DATE: March 16, 2024
TO: Greg Clarke, PE
FROM: Jim Buckman, PE
SUBJECT: Coors/St. Josephs Intersection Review
CC: Nancy Perea, PE; Margaret Haynes, PE

Parametrix reviewed the preliminary design of improvements to the NM 45 (Coors Boulevard) and St. Josephs Drive intersection in Albuquerque. The project will include improvements to the Coors/St. Josephs intersection and to St. Josephs Drive from Atrisco Drive to Coors. These improvements are necessary to accommodate increased traffic from proposed development west of Coors to the north and south of St. Josephs. The exhibits in the file, "24-02-02 Updated Roadway Exhibits.pdf" (Roadway Exhibits) by RESPEC Community Design Solutions were used for the detailed review. The design is approximately 30% complete, so not all details were available at this stage. The "Oxbow Development/Coors Pavilion (St. Josephs Dr./Coors Blvd.) Final Traffic Impact Study" (TIS), December 20, 2020, by Terry O. Brown, P.E. was also used for the analysis. The review focused on the improvements that would affect NMDOT facilities and traffic along Coors.

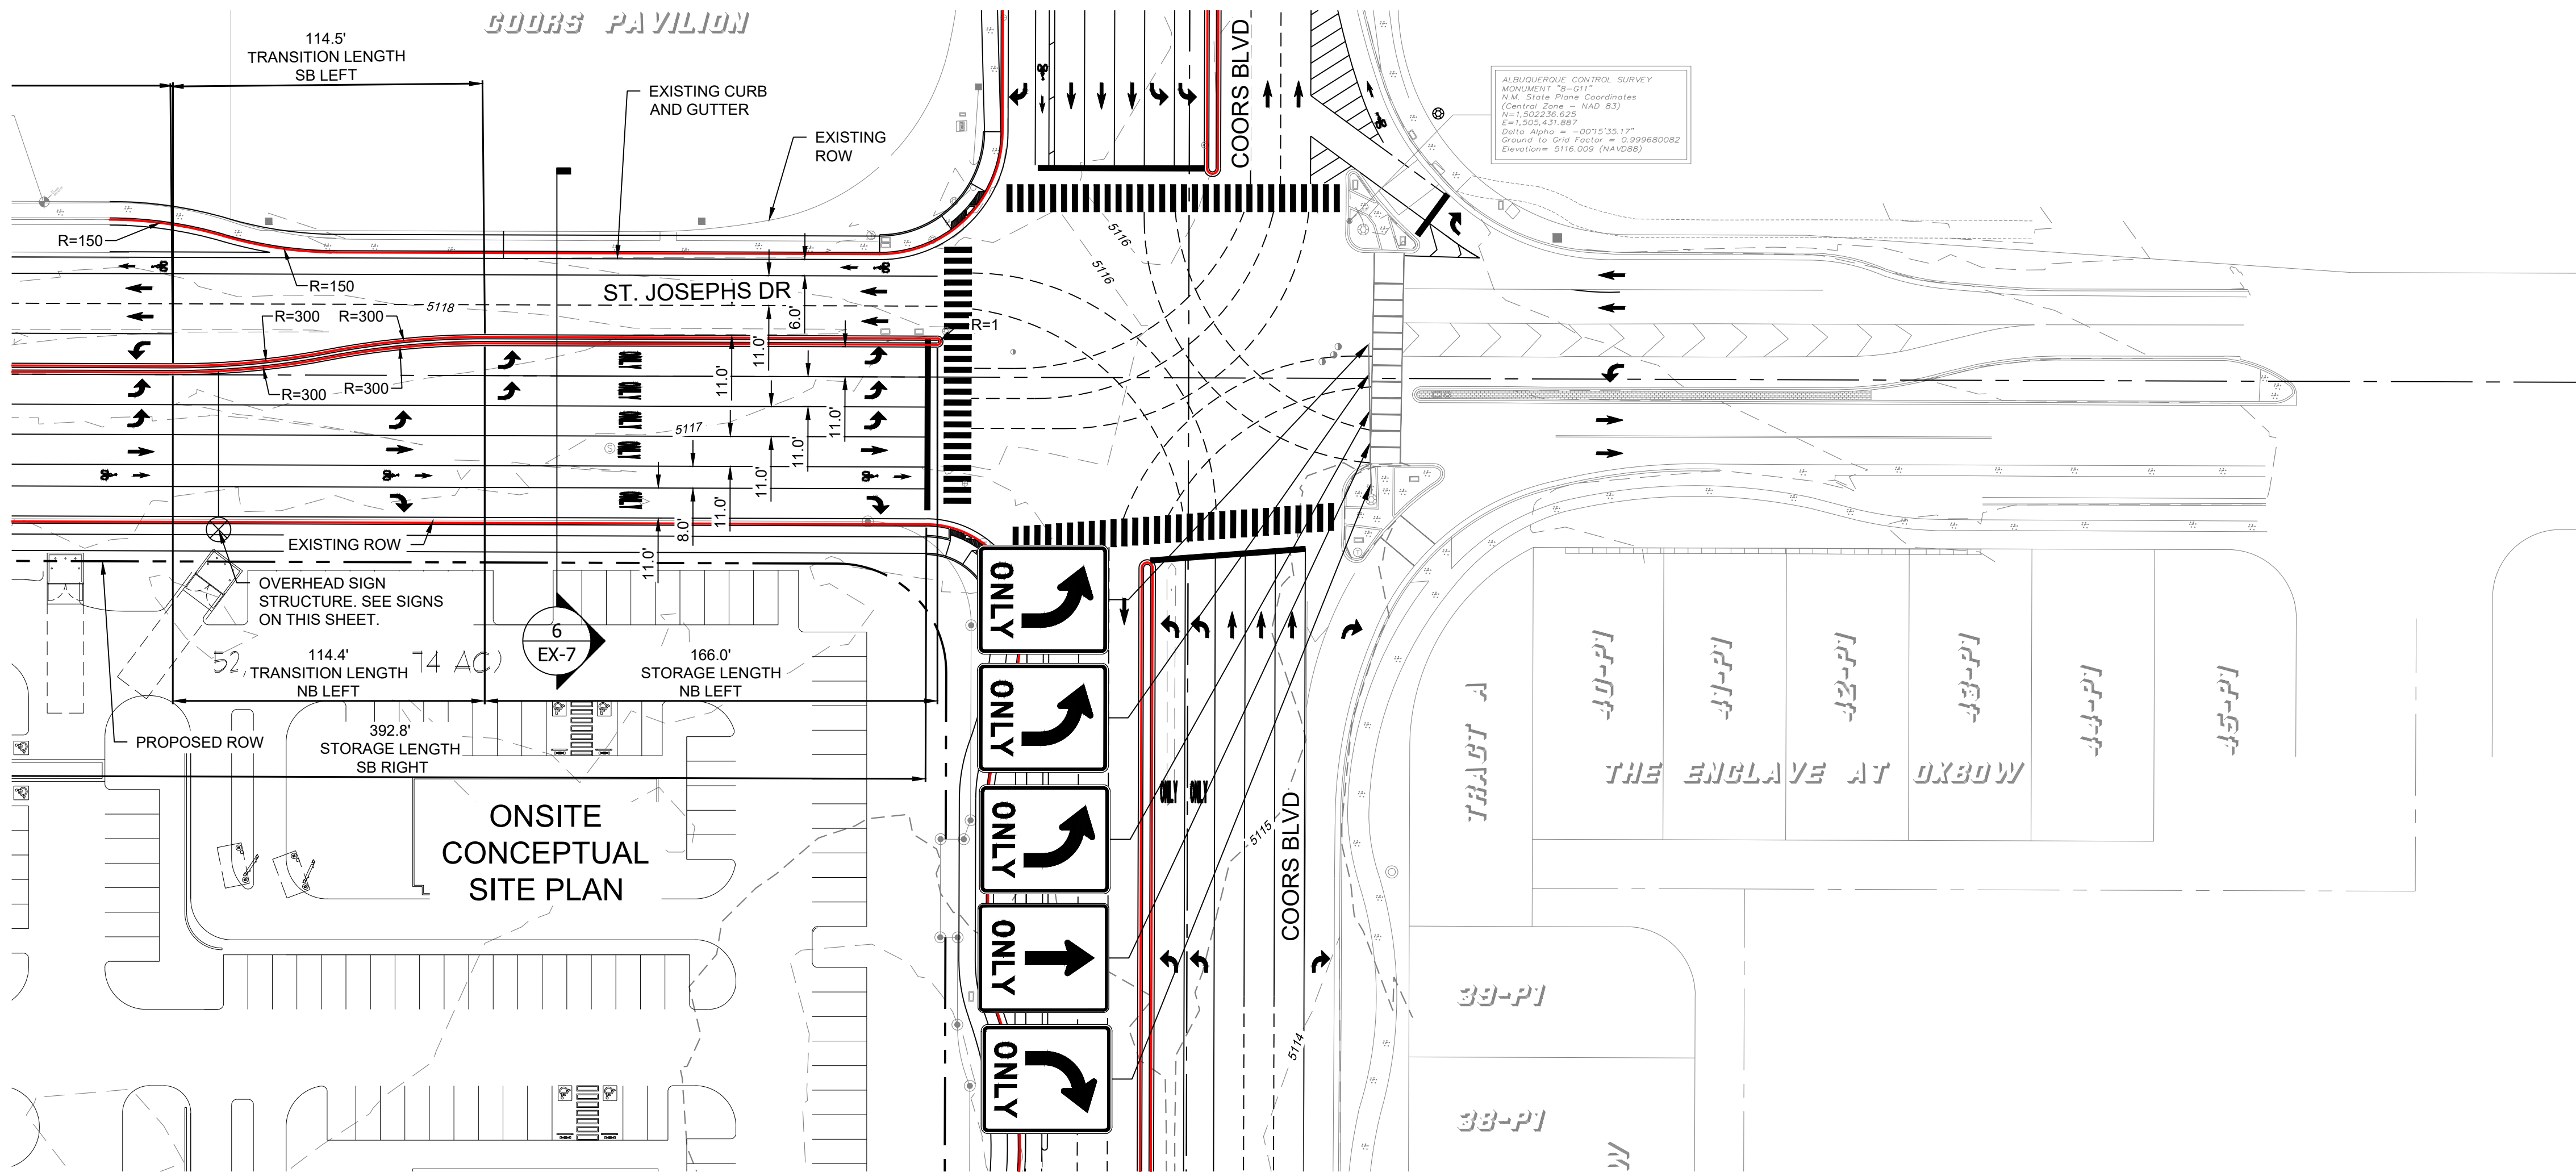
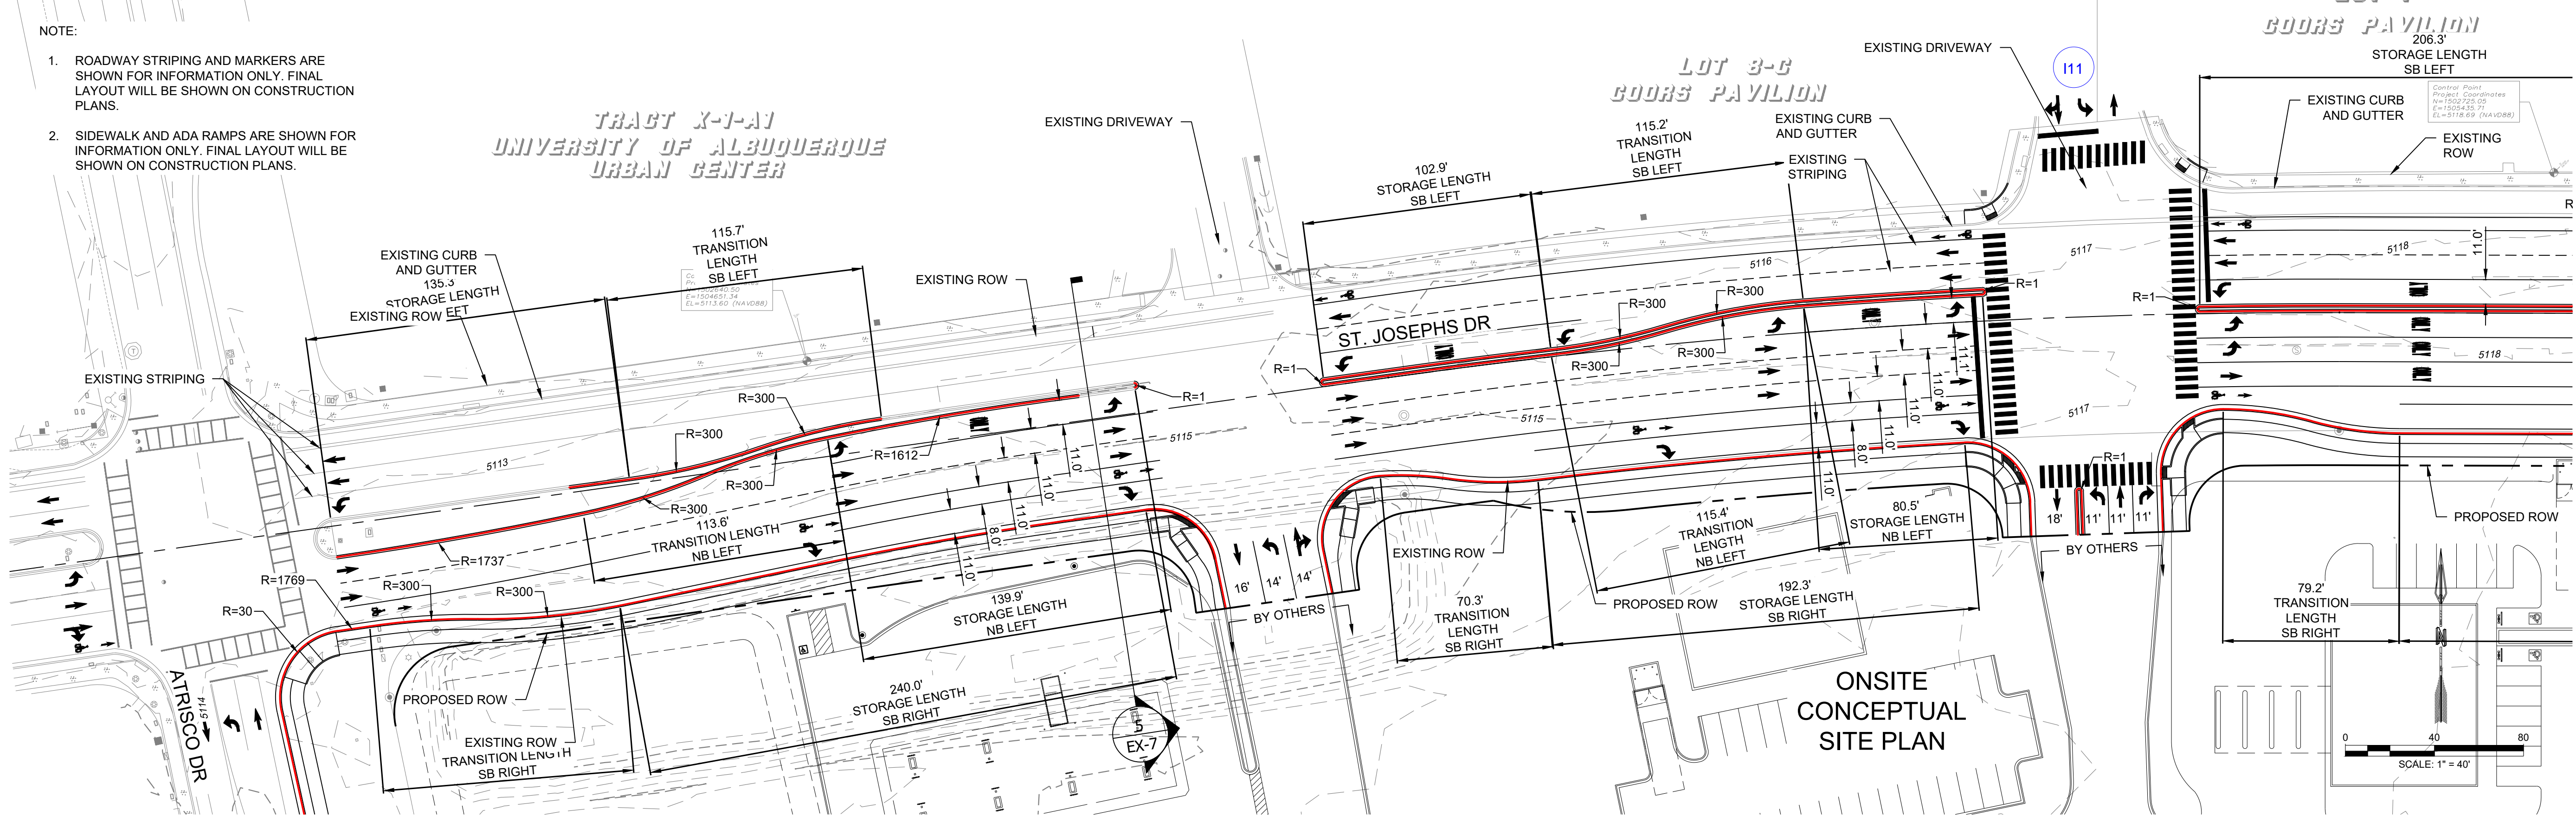
The criteria considered during this review are numbered in the attached checklist. These were grouped by intersection geometry, pedestrian facilities, and bicycle facilities. Where the proposed design appears to differ from the review criteria, comment key notes are shown with blue circles on the Roadway Exhibits.

The preliminary design shows lane widths on Coors being reduced from 12' to 11'. This is a proven safety measure and should be retained in the proposed design.

Intersection Concept Plan

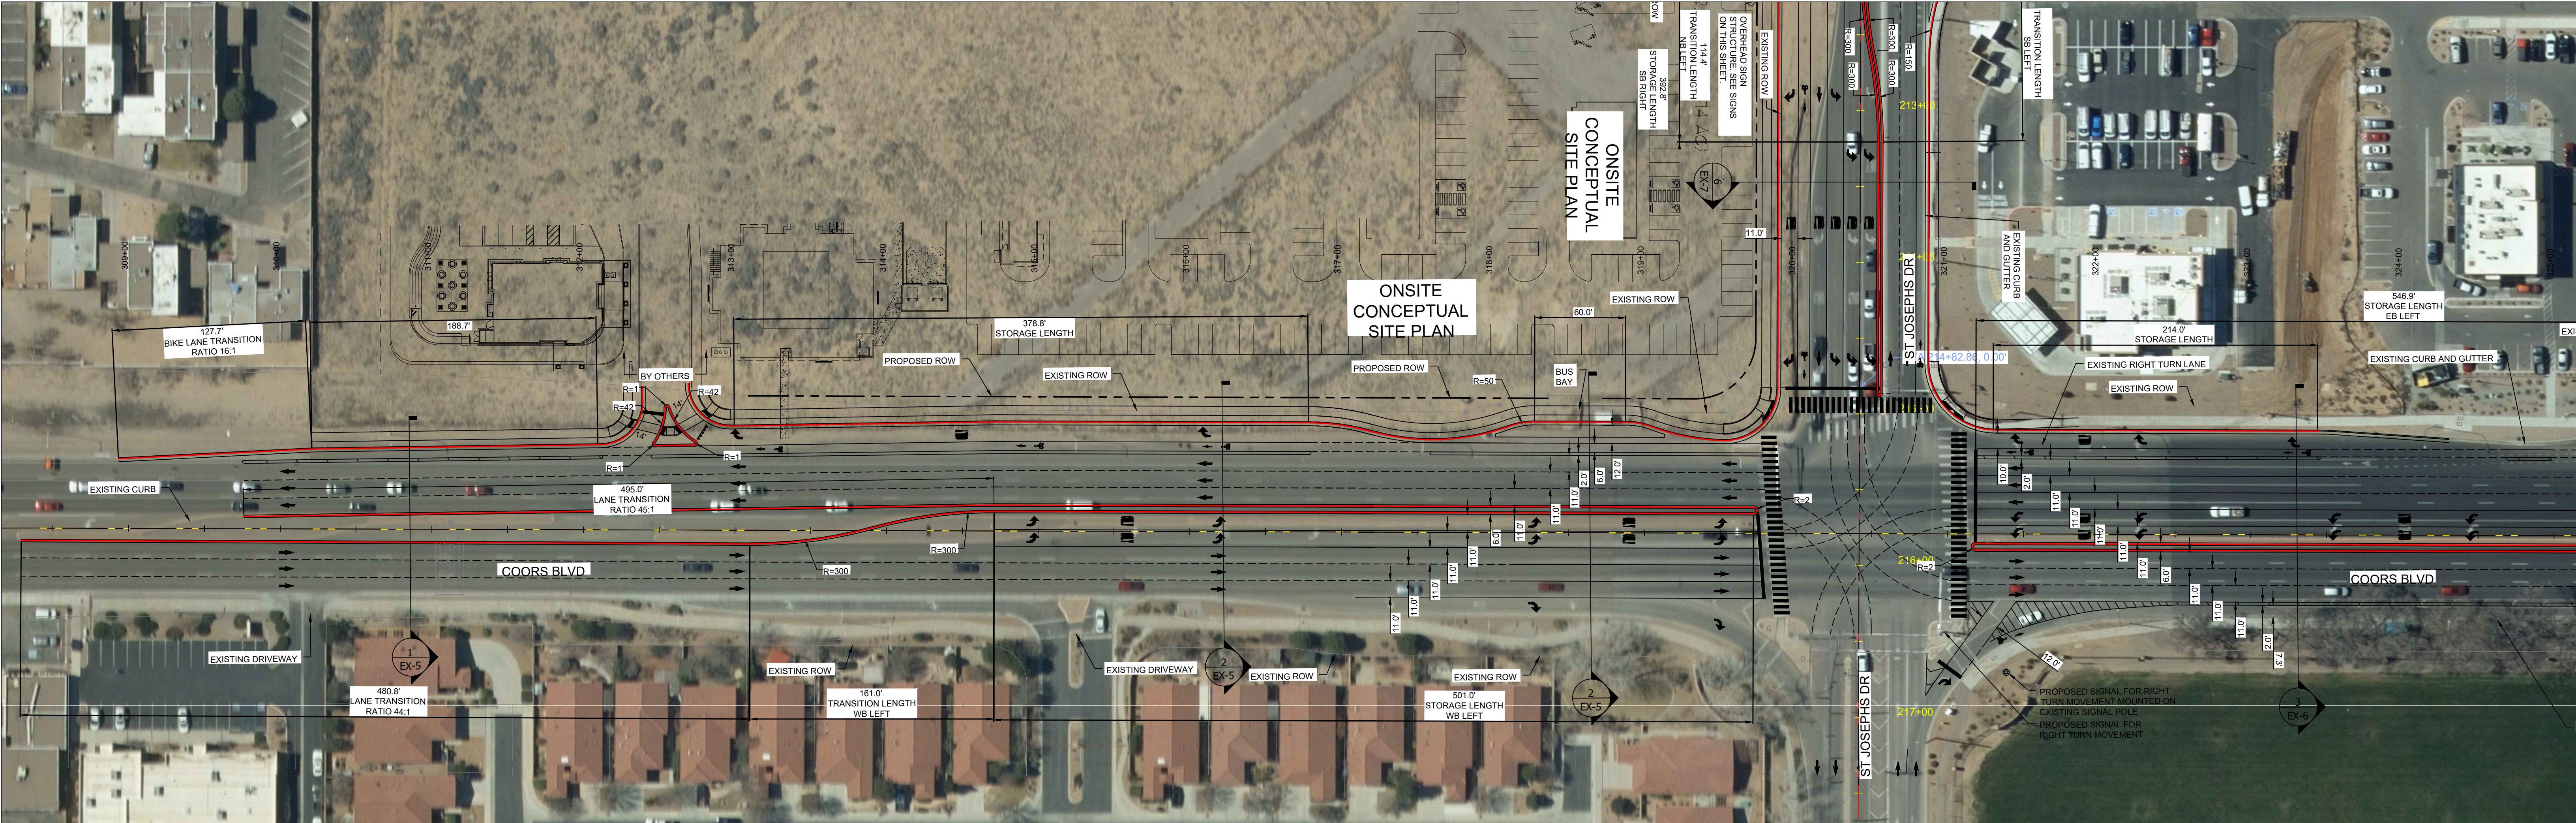
Several options are discussed below, along with their pros and cons. The options are conceptual, and further investigation would be needed before final recommendations are made. To illustrate some of the options, a conceptual plan and typical cross sections are attached. The conceptual layout assumes widening on both sides of Coors. This is per NMDOT standard practice, and it was helpful in identifying potential constraints and impacts. Note the preliminary design holds the existing curb on the east side of Coors. Other innovative design options also may be considered.

Extend curbs on the east leg to eliminate free right-turns, with curb radii of 10' to 15' +/- . At the northwest corner, provide a 40' +/- radius for semi-truck access. At the southwest corner, provide a 25' radius.

Note the 15' radius at the southeast corner was in part to help avoid impacts to the existing traffic signal. Semi-trucks making the northbound to eastbound right-turn could encroach into the Coors outside through lane to make the turn. St. Josephs east of Coors serves the high school and residential neighborhoods, so the truck turning volume is expected to be negligible, but it would need to be investigated further.

Intersection Concept Typical Sections

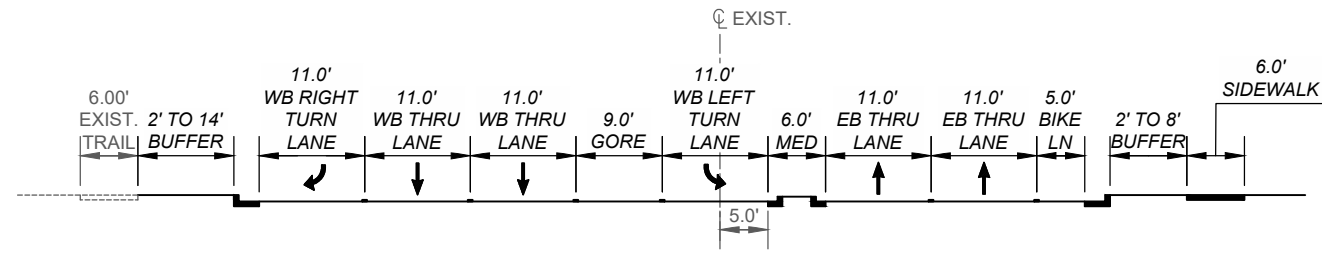
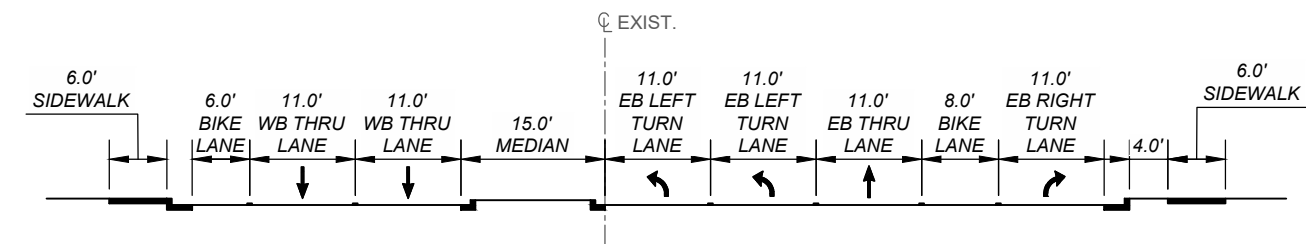
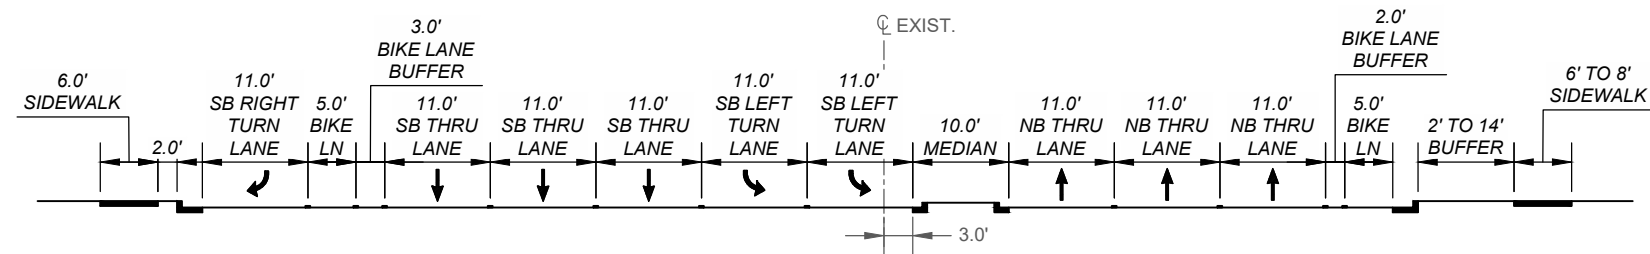
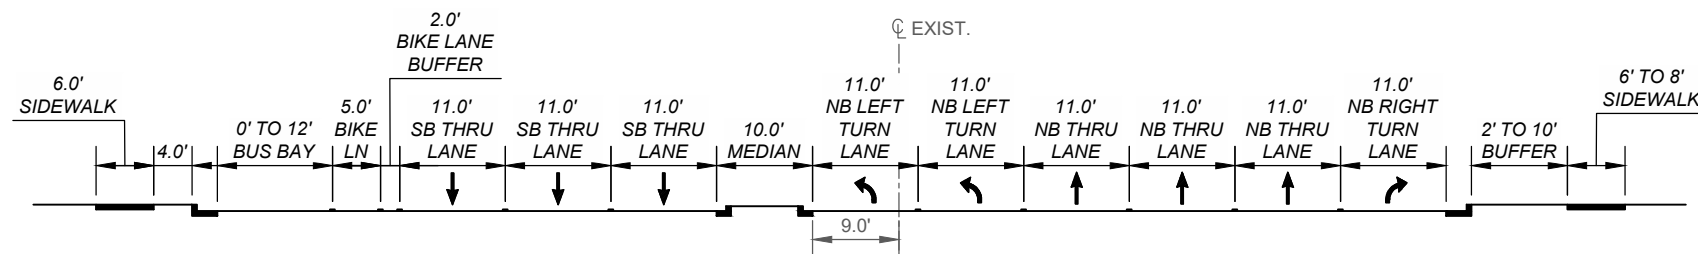
Widen the roadway slightly to provide median refuge on the north and south legs of the intersection.
